UNITED STATES PATENT AND TRADEMARK OFFICE

Office Action Summary

09/866,092

DETAILED ACTION

Fig. 2j

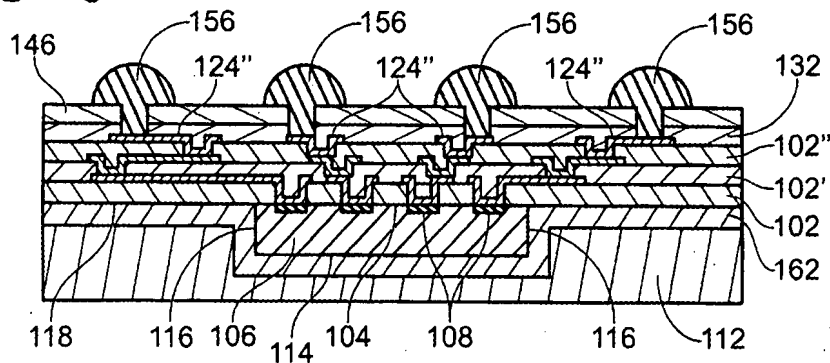
6,861,284 B2. Ma discloses (see, for example, Fig. 2j) a package (multi-layer printed circuit board) comprising an encapsulation material (circuit board substrate) 112 having a first substrate surface and a second substrate surface, die (first integrated electronic component) 106, cavity, flex component (first dielectric layer) 102, conductive trace (metallic layer) 124, electrically conductive first via, element (second dielectric layer) 102', and electrically conductive second via.

Ma does not disclose the circuit board substrate being polymeric. However, Wojnarowski discloses (see, for example, FIG. 1(e)) an integrated module substrate comprising a chip 14, and substrate molding material (circuit board substrate) 24. In column 7, lines 50-62; Wojnarowski discloses the substrate molding material being polymers (polymeric). Therefore, it would have been obvious to one of ordinary skill in the art at the time of invention to have the circuit board substrate being polymeric in order to have a material that adequately supports a die in a substrate form, and any overlying layers wherein the material is not prone to cracking.
